SWT Planning Committee

Thursday, 5th January, 2023,
1.00 pm

5. **3/21/22/105 - Erection of ground mounted solar panels Avondale, Martlet Road, Minehead, TA24 5QD** (Pages 5 - 14)
6. **42/22/0043 - Variation of Condition No. 2 (approved plans), for the inclusion of a turning head at the entrance of the approved pumping station compound, of application 42/20/0042 at Orchard Grove New Community, Comeytrove Rise, Taunton** (Pages 15 - 114)

Application Details	
Application Reference Number:	42/22/0043
Application Type:	Section 73 – Variation of Condition
Description	Variation of Condition No. 02 (approved plans), for the inclusion of a turning head at the entrance of the approved pumping station compound, of application 42/20/0042 at Orchard Grove New Community, Comeytrove Rise, Taunton
Site Address:	Orchard Grove, Land off Comeytrove Lane, Taunton
Parish:	Trull
Conservation Area:	No
Somerset Levels and Moors RAMSAR Catchment area:	Yes
AONB:	No
Case Officer:	Simon Fox, Major Projects Officer (Planning) 07392 316159 s.fox@somersetwestandtaunton.gov.uk Should you wish to discuss the contents of this report item please use the contact details above by 5pm on the day before the meeting,

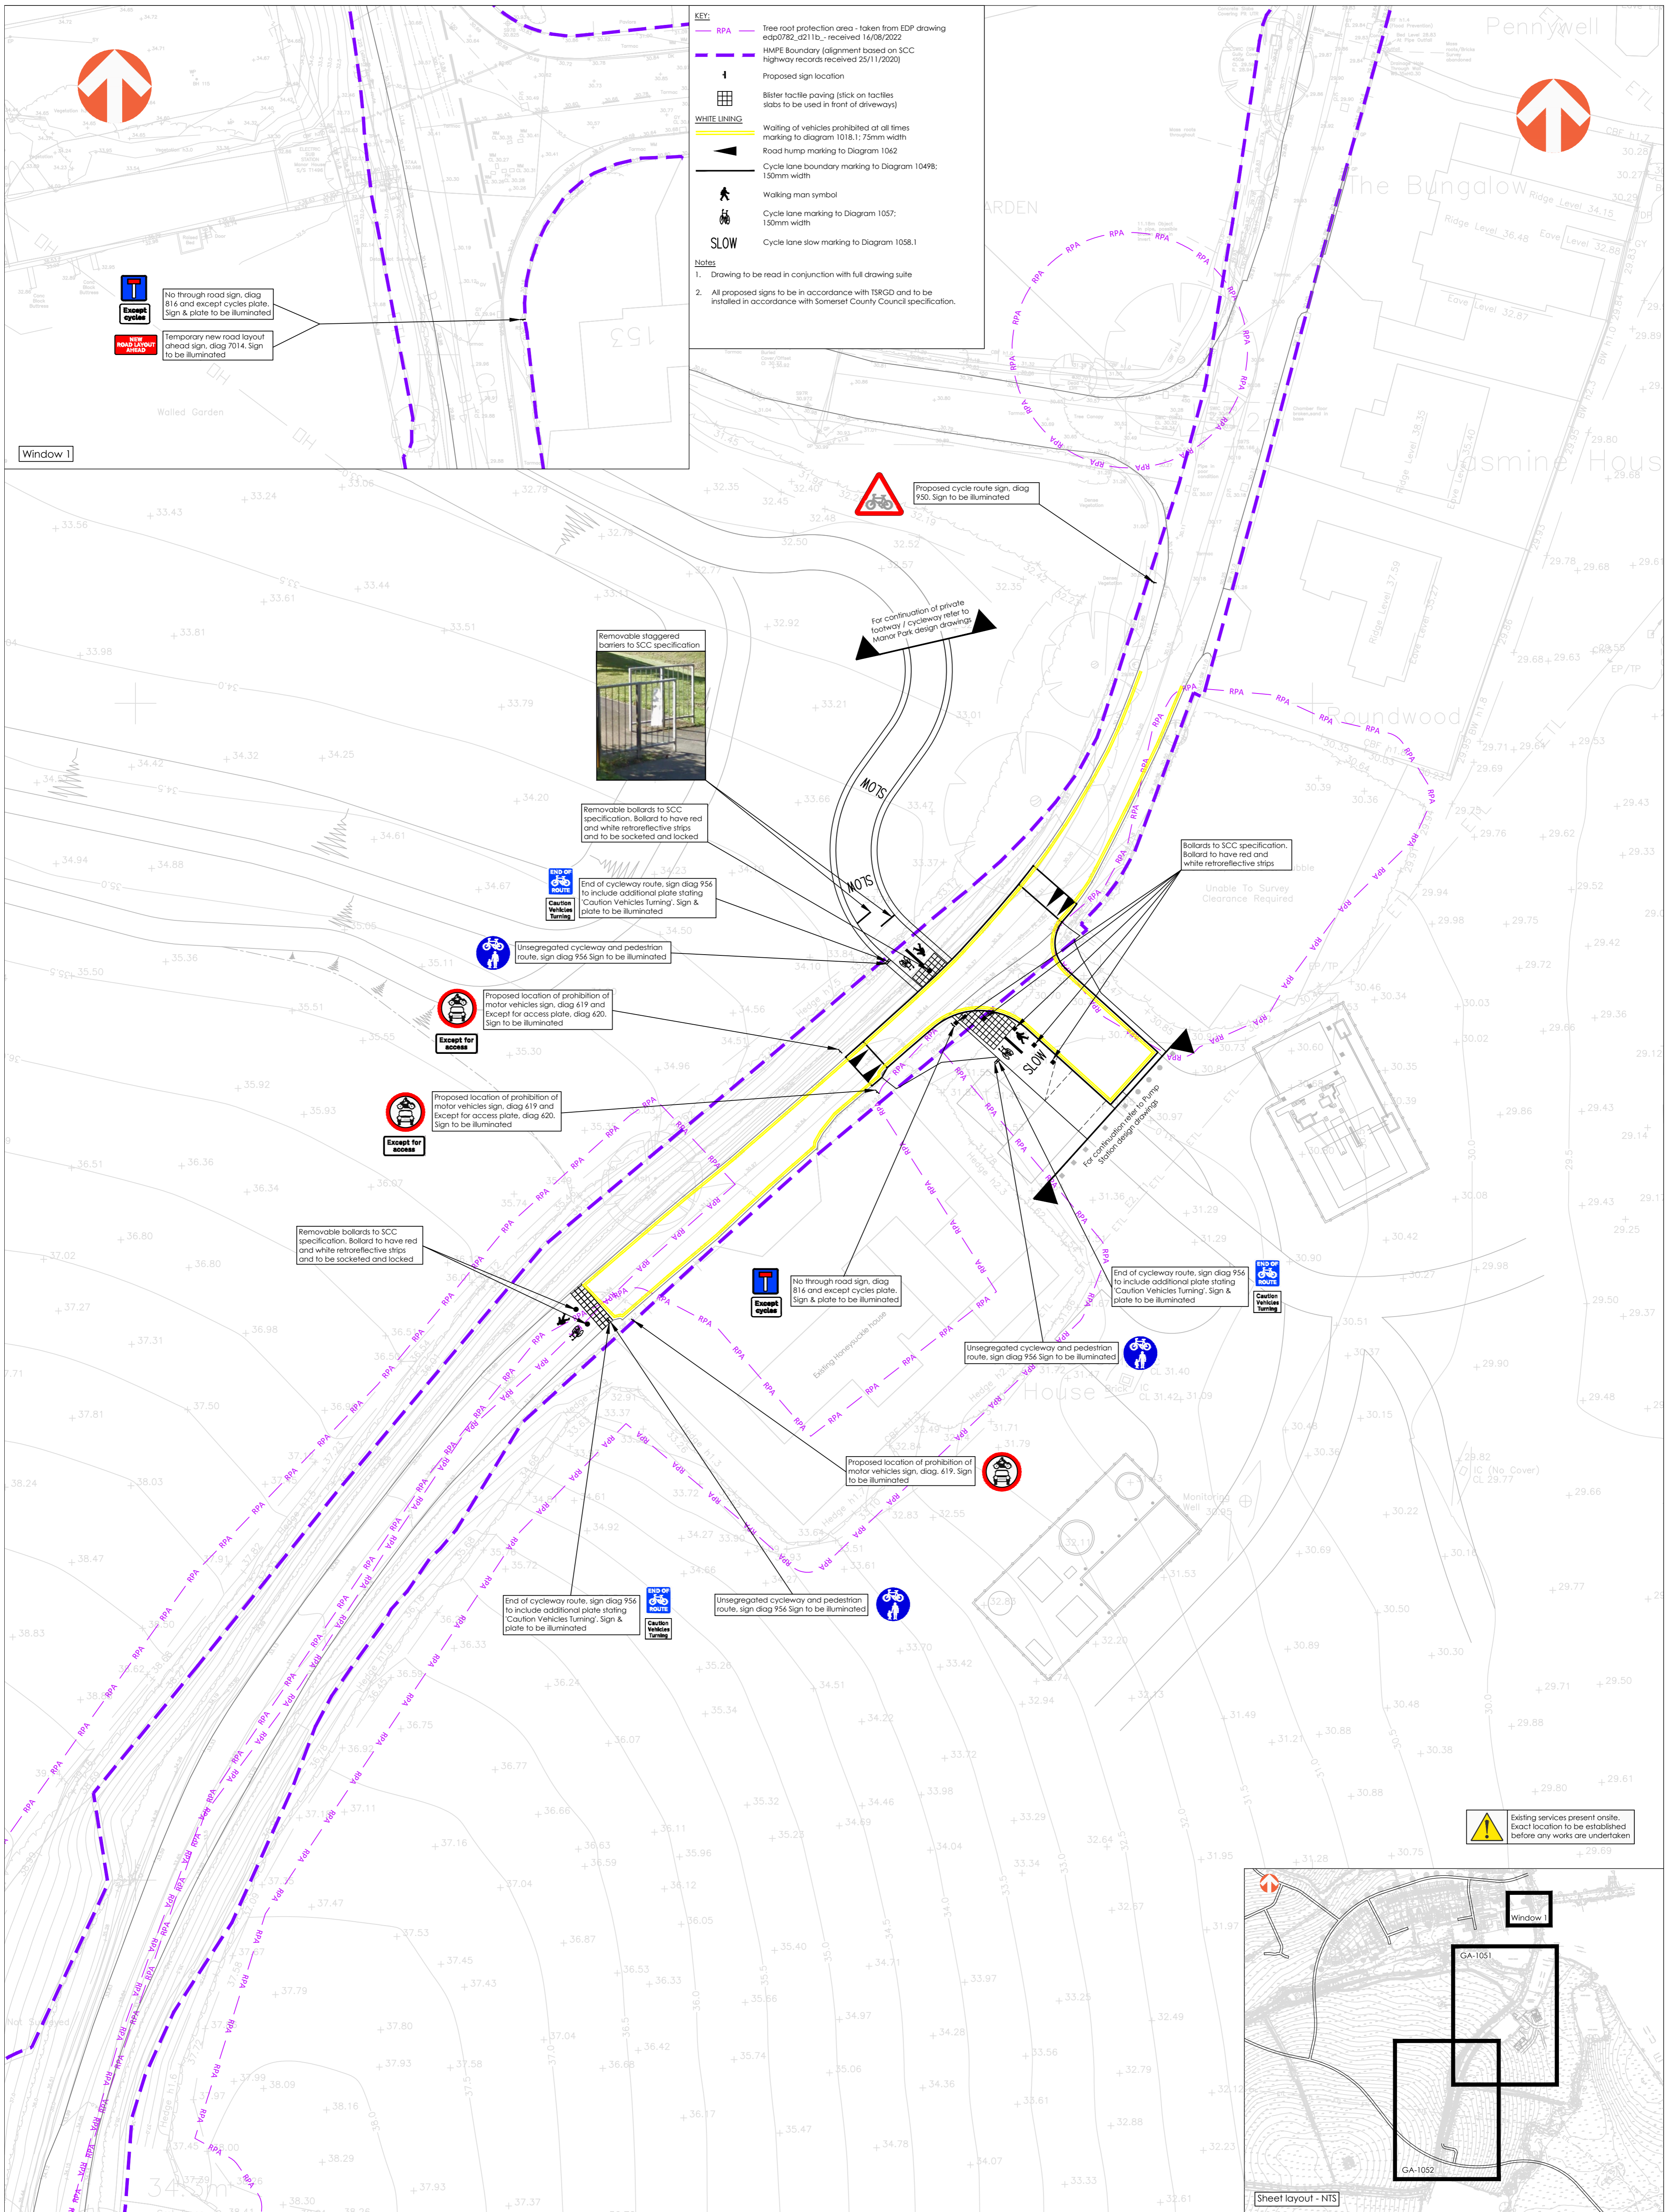
<p>before having priority progressing through the park</p>	<p>proposed route, crossing in the vicinity of the proposed turning head and then proceeding along the pumpstation access, before continuing back on the footway/cycleway within Horts Bridge Park. Clearly short cuts down a steep embankment could present a safety hazard.</p>
Vertical Alignment	<p>The vertical alignment of the private shared footway/cycleway is proposed no steeper than 1:14 (based on minimum SCC guidance) with a 2.4m level area (1:40) at the point of crossing Comeytrove Lane.</p>	<p>The vertical alignment of the private shared footway/cycleway is shown no steeper than 1:14 (based on minimum SCC guidance) with a 2.4m level area (1:40) prior to intersecting Comeytrove Lane. To achieve an acceptable gradient the alternative option results in a significantly long route</p>
Earthworks	<p>Earthworks/banking is required at a maximum grade of 1:3 (self-supporting) to enable the proposed footway/cycleway to grade down to Comeytrove Lane. This is over an approximate length of 35m. The height of the existing sunken lane on the northern side of Comeytrove Lane is approximately 3.4m, with the lane being at level on the southern side, so not requiring any earthworks. This results in approximately 767m³ of excavated material.</p>	<p>Earthworks/banking is required at a maximum grade of 1:3 (self-supporting) to enable the proposed private shared footway/cycleway to grade down to Comeytrove Lane. This is over an approximate length of 80m. The height of the existing sunken lane at this location, on the northern side, is approximately 4.2m, and 1.4m on the southern side adjacent to honeysuckle house This results in approximately 2,001m³ of excavated material with the extents identified on the alternative sketch option.</p>

Street lighting	<p>There is no existing street lighting on Comeytrove Lane in this location. The nearest and last existing streetlight is 143m northeast at the junction with Queens Way. However, due to the proposed turning head, Pumpstation service access and footway/cycleway link all</p>	<p>Once again there is no existing street lighting on Comeytrove Lane in this location. The nearest and last existing streetlight is positioned 191m northeast at the junction with Queens Way. However, as this becomes a rural lane and the alternative option</p>

TITLE: OFFSITE SIGNS & LINES PLAN - COMESTROW LANE TURNING HEAD

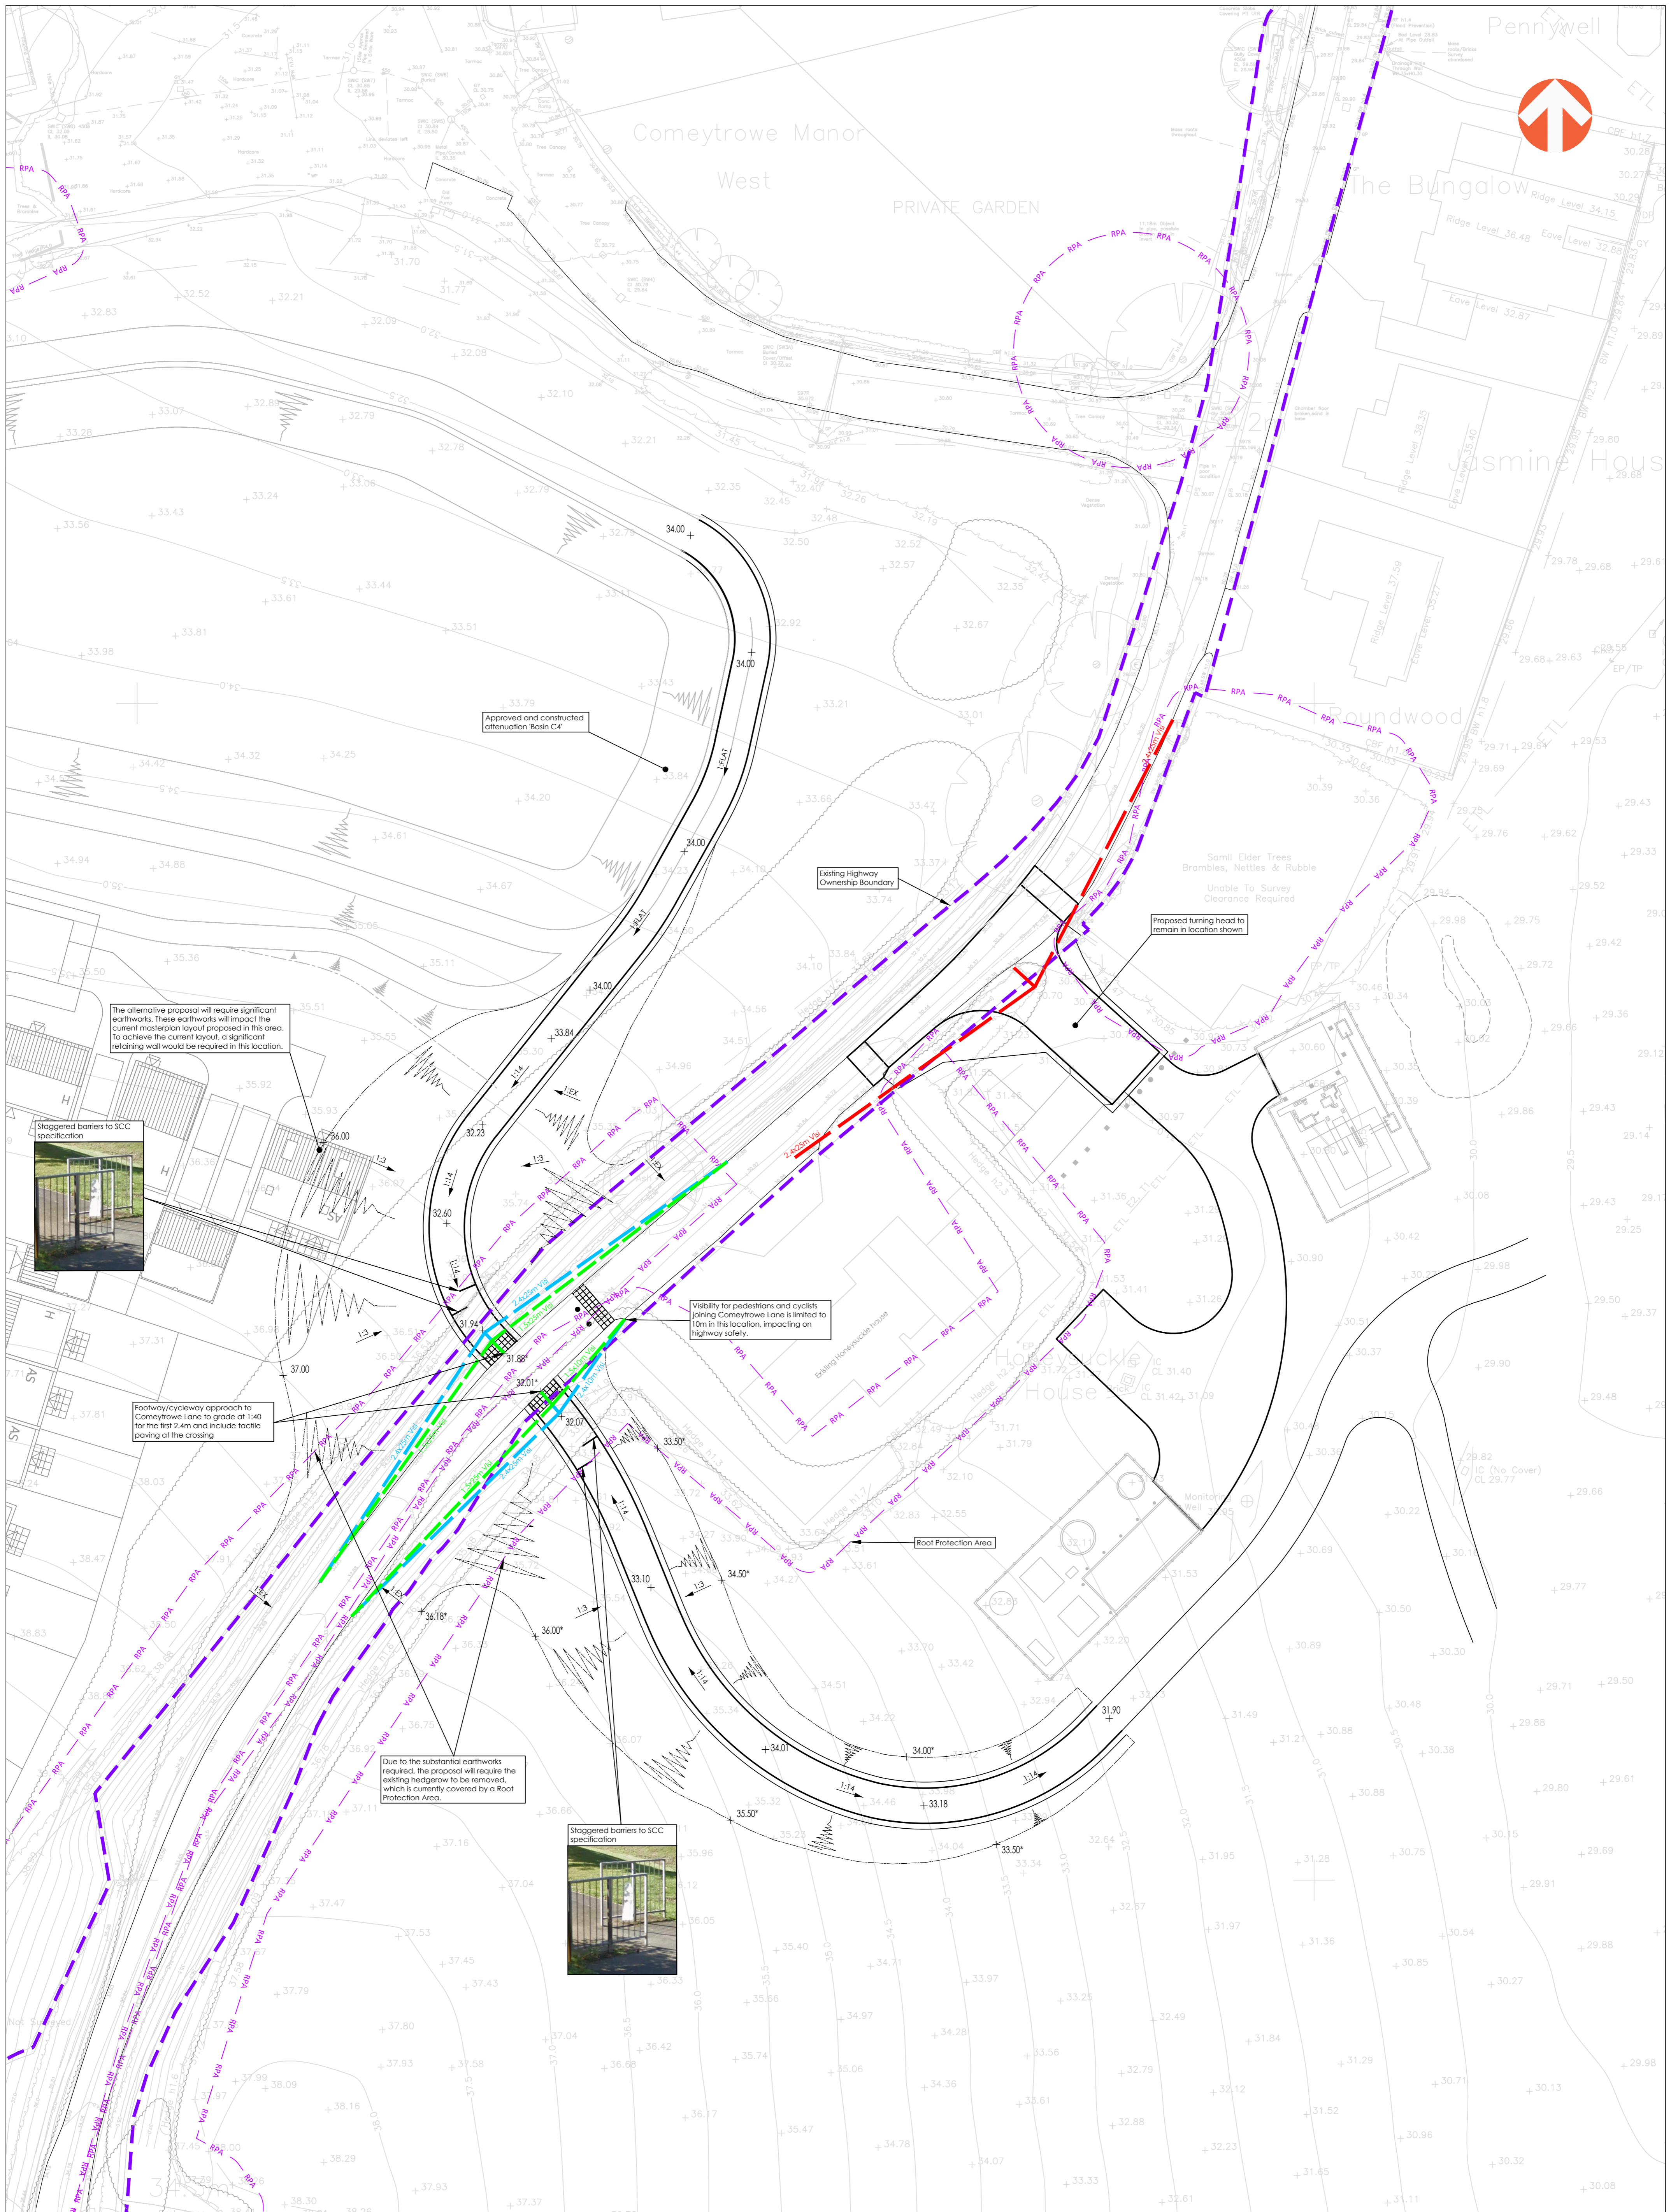
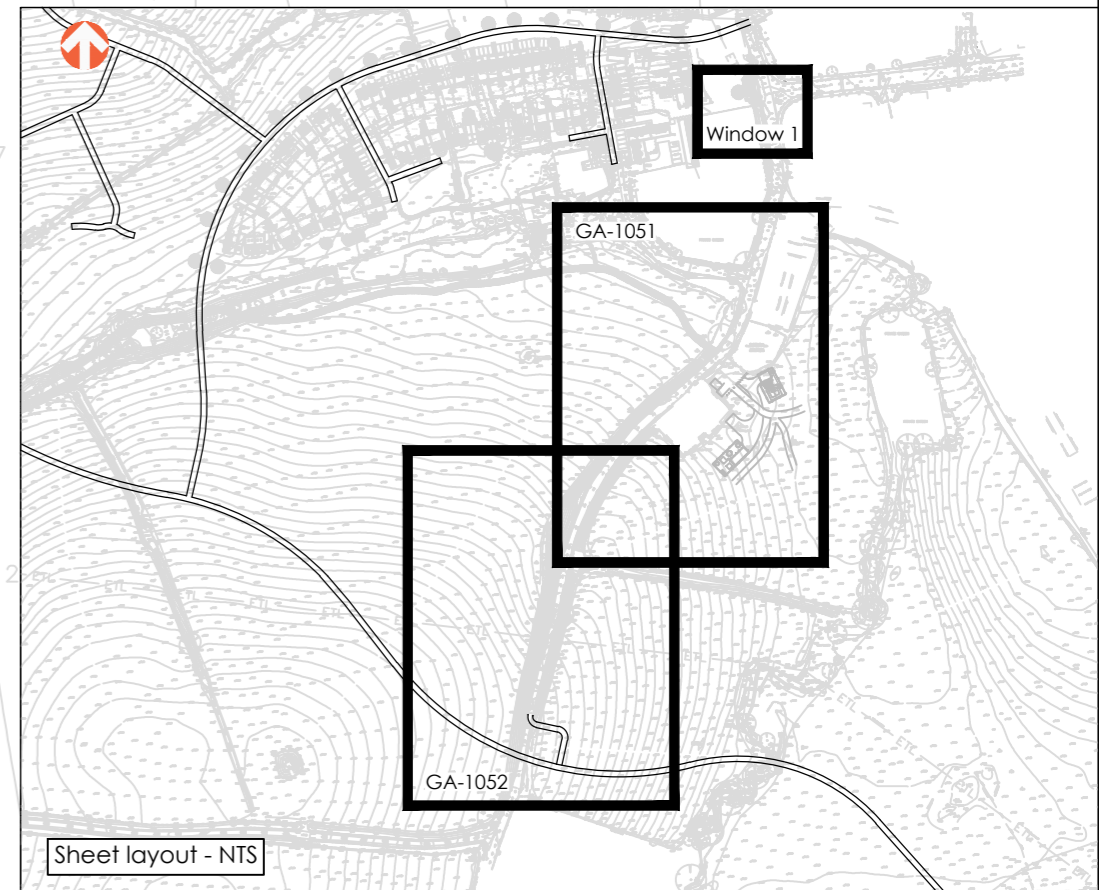
Finally, the Highway Authority understands that there were previous concerns over the change in priority for pedestrians and cyclists who would be crossing Comeytrove Lane. Drawing 1083-03-J-GA-1051 Rev C provides details of the on and off carriageway signage which will be provided when the scheme is implemented whilst staggered barriers have been put in place to slow cyclists as they approach the crossing point.

Signing and lining	The proposed signing is in line with current national guidance (TSRGD and TSM) and is shown on the proposed supporting signing drawing 1083-03-J-GA-1051-Rev D. The proposed signs identify no through traffic accept access, prohibition of motorised vehicles, appropriate footway/cycleway signing for an uncontrolled crossing; as well as the addition of caution of vehicles turning and cycle warning signs.	Although the pedestrian/cycleway would be removed from the proposed turning head location, it is envisaged that many of the same signs would be required for the alternative option, similar to those currently proposed on the supporting signing drawing 1083-03-J-GA-1051-Rev D. However, as these areas are not required or proposed to be lit, illuminated signs would not be required.
Other Highway features	The turning head is proposed as a tabletop with ramps to reduce vehicle speed. Tactile paving is proposed at the footway/cycleway crossing of Comeytrove Lane again informing pedestrians & cyclist that vehicles on carriageway have priority. A series of bollards are proposed adjacent to the southern footway/cycleway	The proposed turning head is to remain in position as a tabletop with ramps to reduce vehicle speed. Although the alternative footway/cycleway is south of Honeysuckle House, tactile paving would still be required at the crossing of Comeytrove Lane. This is to inform pedestrians & cyclist to give way to those travelling

Given the view of the Highway Authority that the original scheme remains acceptable in highway safety terms it is not felt necessary to change the original officer’s recommendation (save for the amended plan DrNo 1083/03-J-GA-1051 RevD Offsite Signs and Lines Plan) and the amendments made to Condition 06 via the Update Sheet to the previous meeting, attached as **Appendix 5**.

Figure 5.1 – PIA data 2016 to 2020

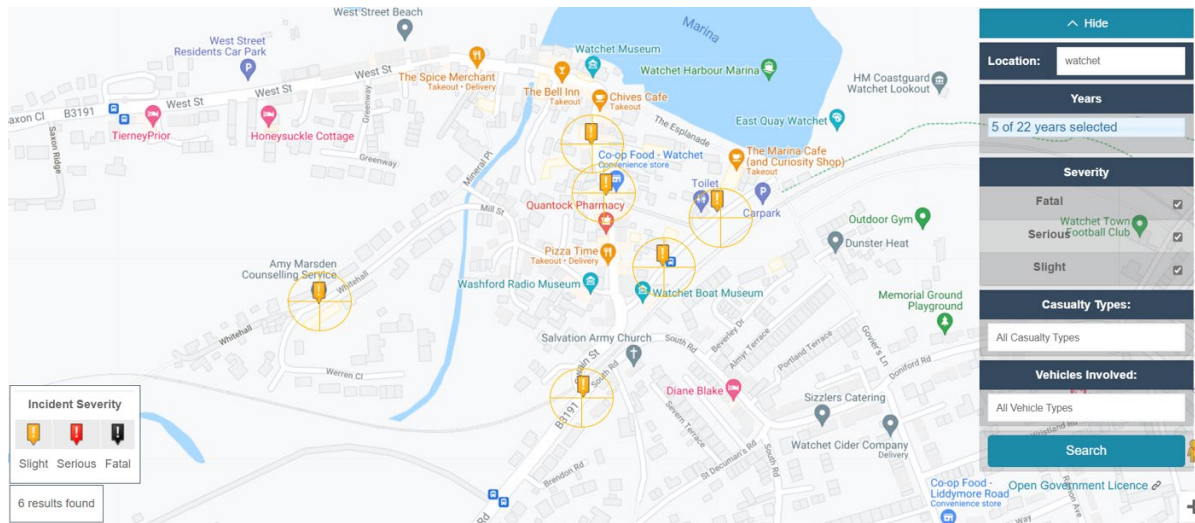
- 5.10. The TA includes an assessment of personal injury accidents for the three years prior to the TA being written i.e. 2014-2017. This information is therefore out of date and should be repeated. The assessment should be for a five-year period in accordance with SCC and Government guidance. An initial assessment using the CrashMap website suggests an increase in incidents compared to the 2017 TA as shown below

- 5.11. The proposed development will generate additional traffic in five of the six incident locations and will result in additional pedestrians and/or cyclists in all six. It should be noted that a Fatal PIA occurred on the B3191 in 2021 to the west of the development site but is not yet listed on the CrashMap website. The proposed development will also increase vehicle traffic in that location.
